# STAFF REPORT

RE: **727 Fort Street (project number #TP2020-0007)**

FROM: Karen DeMaria, City of Key West Urban Forestry Manager

Recommend Approval of the Final Landscape Plan

# L-1

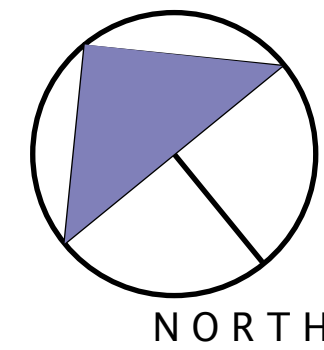
No new vegetation is proposed to be planted along the property line with the residential areas (northeast and northwest boundaries). Opaque fences exist in these areas and pea rock will be placed on the ground. One large Strangler Fig tree and the canopy of a neighboring Mango tree exist in the northwest area. A Bottlebrush tree also exists in the northwest boundary area close to Fort Street. Landscape waivers were approved by the Planning Board for these two areas (Sec 108-347, 348, and 350).

New vegetation is proposed to be planted along Petronia Street and the front of the property and building along Fort Street. There is a large existing mahogany tree on the property along Petronia Street that is to remain. A row of clusia shrubs will be planted along the property line of Petronia and Fort Street except for the two driveway areas along Fort Street. Planting bed areas are being created in the front of the building and will be planted with firebush and firecracker plants. Three tall thatch will also be planted along the driveway near Petronia Street. Therefore, the plan dated 10-6-20 does incorporate the 70% native plant requirement and is in compliance with Sec 108-412 and 413 except that gravel is being placed instead of sod or groundcover. The landscaper has stated that gravel is preferred due to the amount of shade area from the existing mahogany tree. Sec 108-416 does not apply as the entire open space area outside of the structure is considered buffer or streetscape area.

There were three documents used for the quick review (see attached). The first document is the submitted landscape plan. Please note that this plan does not reflect accurately the location of existing trees on or near the property and is not signed and sealed by a landscape architect as required by the City Code. The second document is a page from the building permit file. It shows a planter with plants next to the building along Fort Street. Information about this planter should be on the proposed landscape plan (size of planters, what is being planted-species name and plant count). The third item is a photo of the approved tree map that is also in the building permit file. This photo accurately shows all the trees in the area and should be on the plan that is used to base the landscape plan on.

The dimensions were added where indicated on the plan.

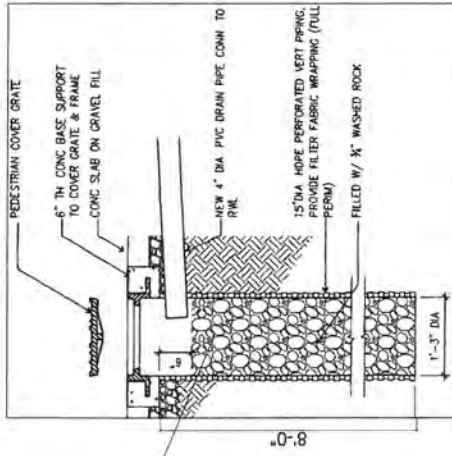
URBAN FORESTRY NOTE  
MAHOAGNY CANOPY TO BE TRIMMED BY OWNER.  
CANOPY TO BE TRIMMED TO MAINTAIN  
POSE NO IMPACT TO ROOF MINIMIZE OR SOLAR  
PANEL EFFICIENCY.
